# PENRITH CITY COUNCIL

## MAJOR ASSESSMENT REPORT

<b>Application number:</b>	DA18/0488
<b>Proposed development:</b>	Demolition of Existing Structures & Construction of Six (6) Storey Residential Flat Building containing 42 Apartments with Communal Roof Top Terrace & Two (2) Levels of Basement Car Parking
<b>Property address:</b>	28 Hope Street, PENRITH NSW 2750 30 Hope Street, PENRITH NSW 2750 26 Hope Street, PENRITH NSW 2750
<b>Property description:</b>	Lot 35 DP 31239 Lot 36 DP 31239 Lot 34 DP 31239
<b>Date received:</b>	14 May 2018
<b>Assessing officer</b>	Gemma Bennett
<b>Zoning:</b>	Zone R4 High Density Residential - LEP 2010
<b>Class of building:</b>	Class 2 , Class 7a
<b>Recommendations:</b>	Refuse

**DRAWING**  
**PROPOSED LANDSCAPE PLAN - GROUND FLOOR**

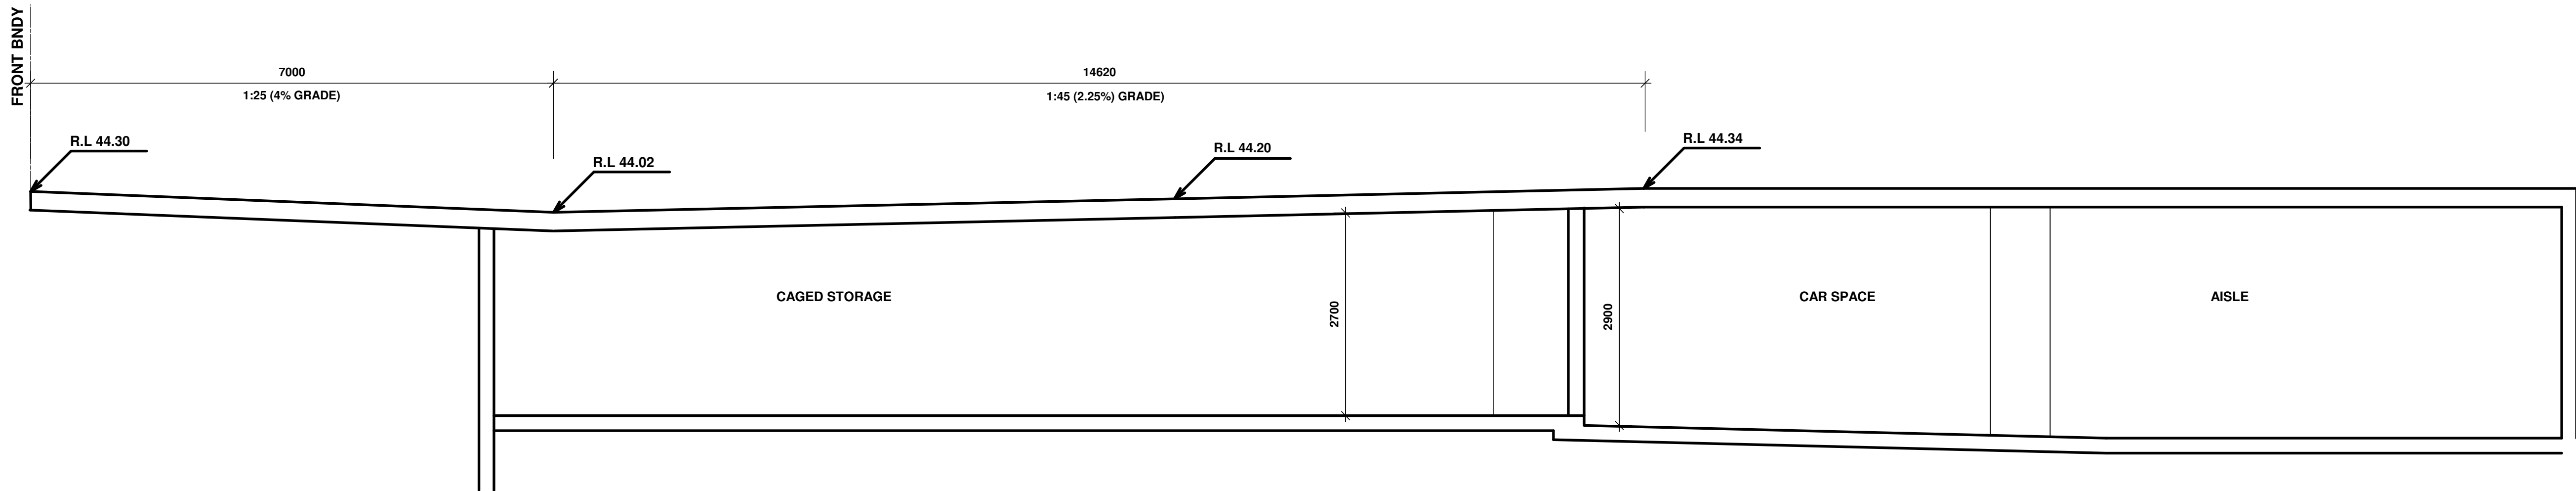
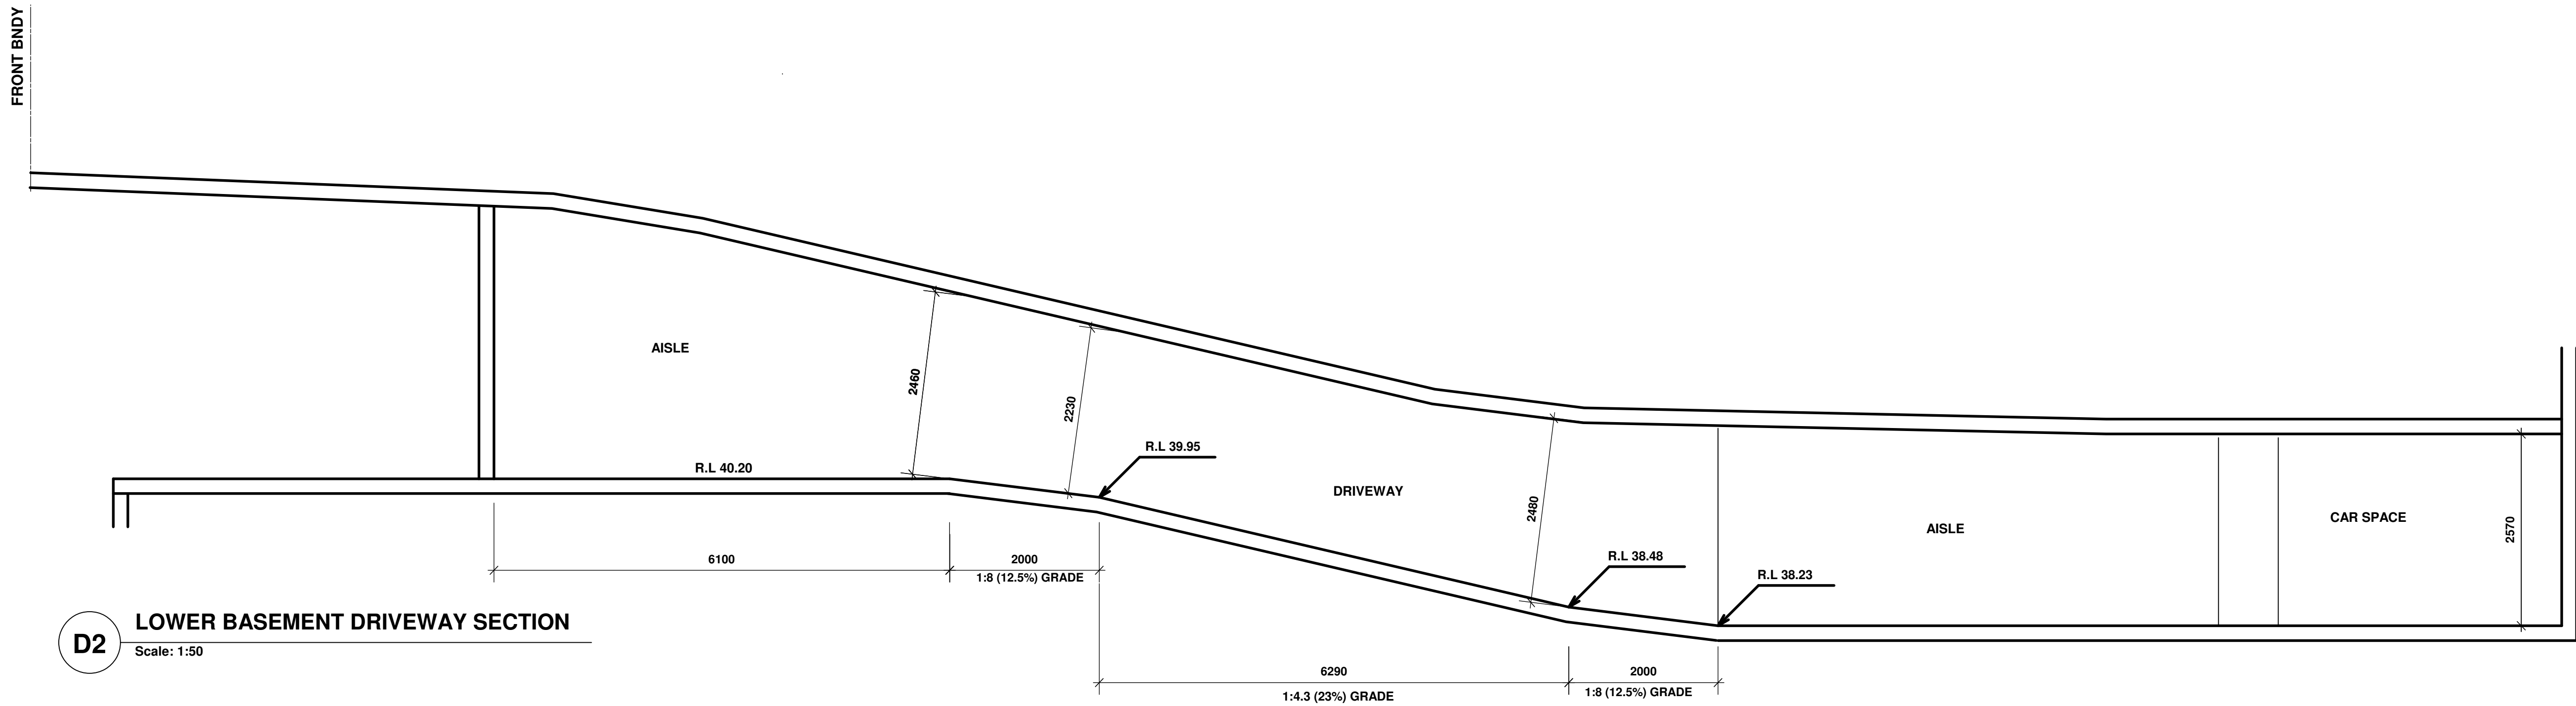
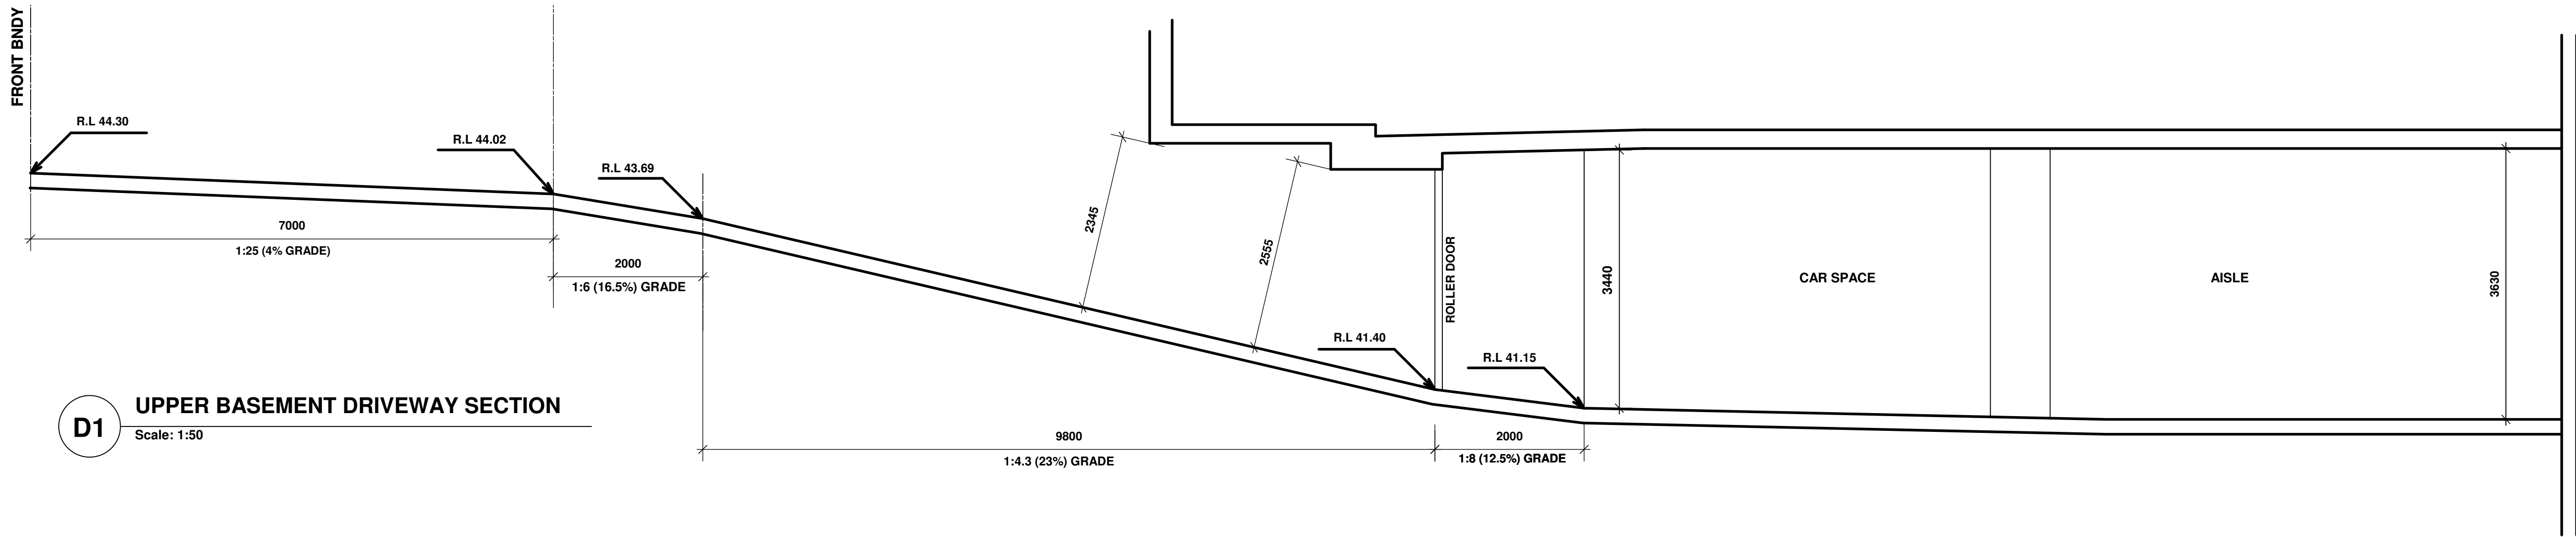
The application has been accompanied with a landscape plan which has identified the provision of landscaping throughout the subject site in association with the proposal. In this regard, landscaping has identified bushes and trees to the front setback area which is considered to compliment the visual impact of any lightweight fencing and low sandstone walls proposed to ground floor unit courtyard areas fronting Hope Street. In addition to the mix of trees, shrubs and grasses provided to each of these courtyard areas, the nature of landscaping proposed to the northern elevation is considered to allow for an appropriate integration with the building design to minimise the impact of architectural features.

The proposal will provide for varied landscaping features to the eastern side setback in association with ground floor courtyard areas which will allow for mature tree planting to deep soil zones. This landscaping is considered to serve as a buffer between the adjoining neighbour while also providing for amenity for future occupants.

Elevated planter boxes associated with terrace areas are proposed, however Council's Landscape Architect has raised concerns in regard to their ongoing health and maintenance, particularly in relation to unit 5, that due to the high retaining walls any planting will receive inadequate sunlight.

The south western corner of the ground floor adjoining the garbage rooms and garbage truck loading bay are maintained as deep soil areas. While not a communal landscape area, plans have identified access to this part of the site to allow for vegetation maintenance.

1. 9am June 21 Winter Shadows
2. Noon June 21 Winter Shadows
3. 3pm June 21 Winter Shadows

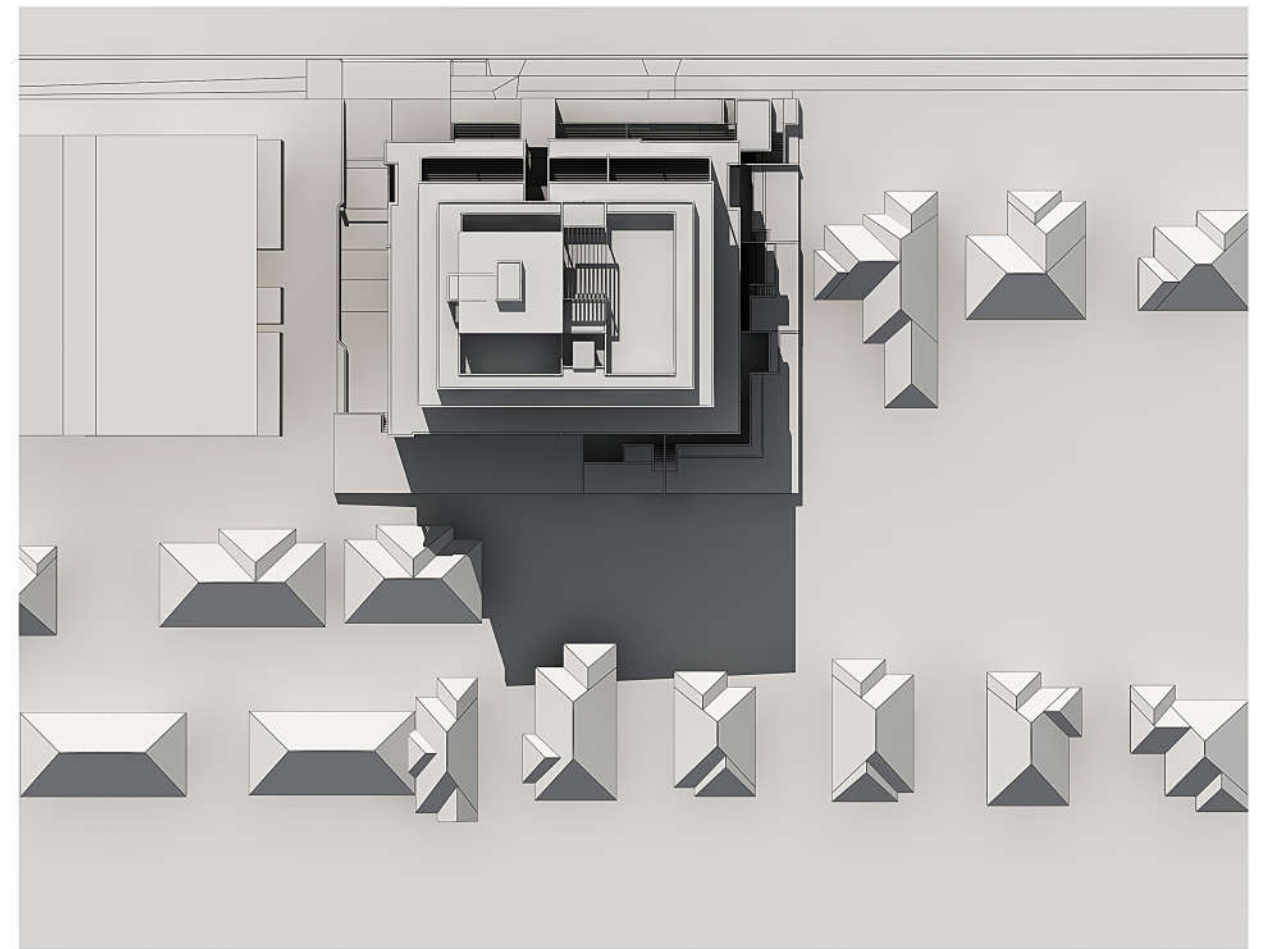
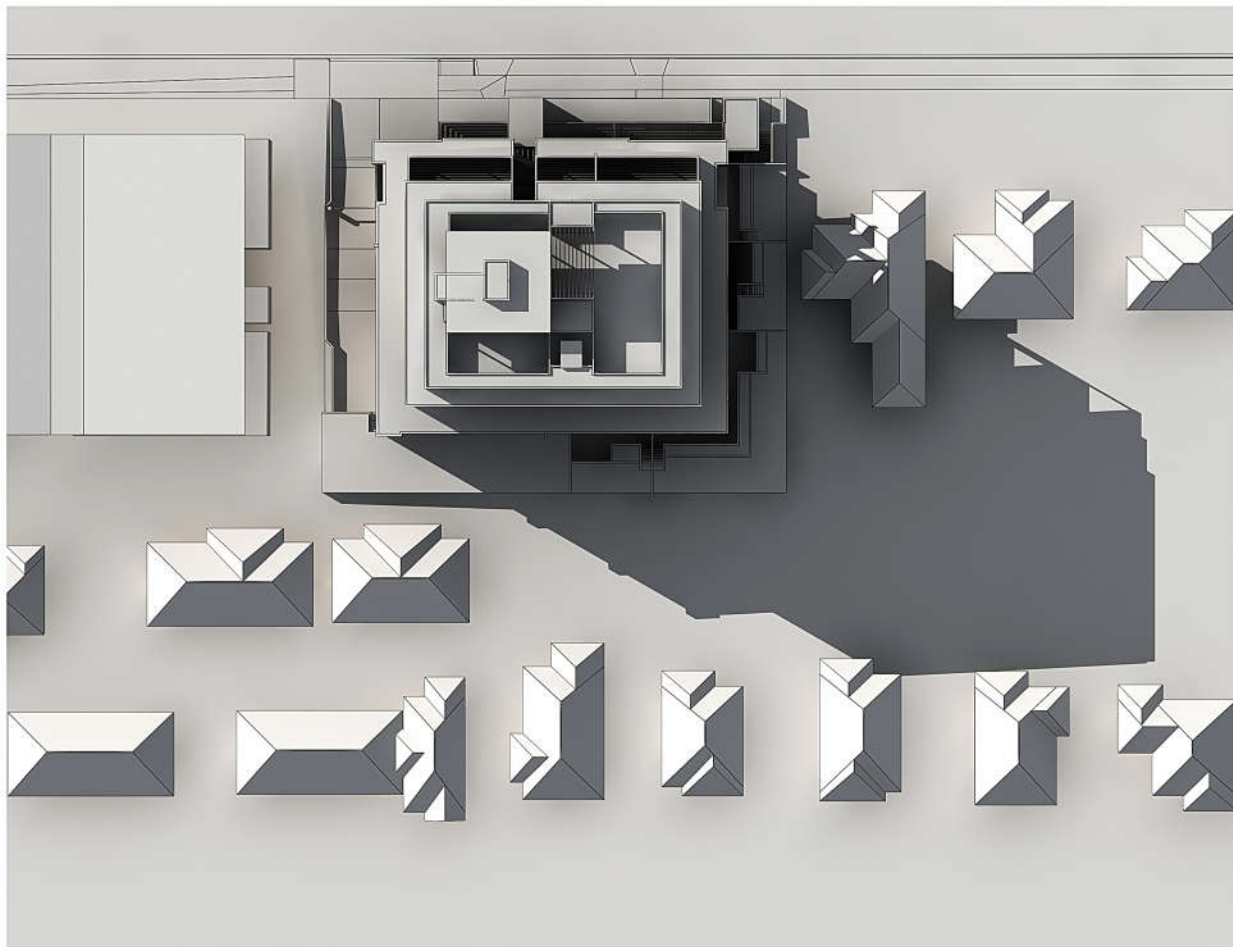
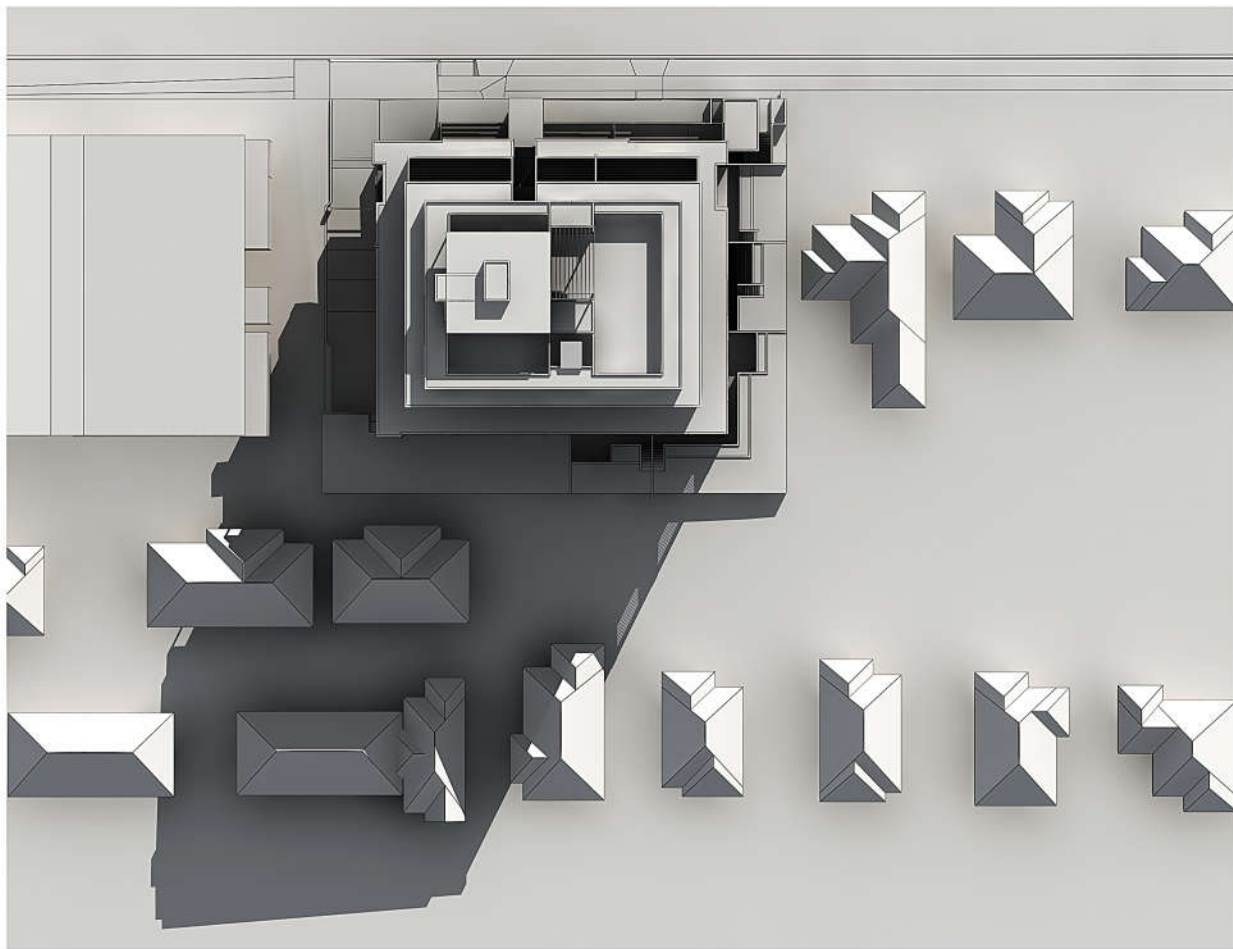
The application has been accompanied by architectural plans which are considered to identify that 26 of the proposed 42 units (a total of 62%) will achieve a minimum 2 hours solar access between 9 am and 3 pm at mid-winter and is therefore non-compliant with the solar and daylight access requirements as provided by the Apartment Design Guide. In addition, 7 of the proposed 42 units (or 17%) will received no solar access which is non-compliant with the requirements provided by the Apartment Design Guide.

It is also noted that the ground floor units 3, 4 and 5 are located below the existing ground level and will receive restricted solar access in this regard. Unit 5 in particular, being located on the south eastern corner of the building, will provide little in the way of amenity for future occupants.
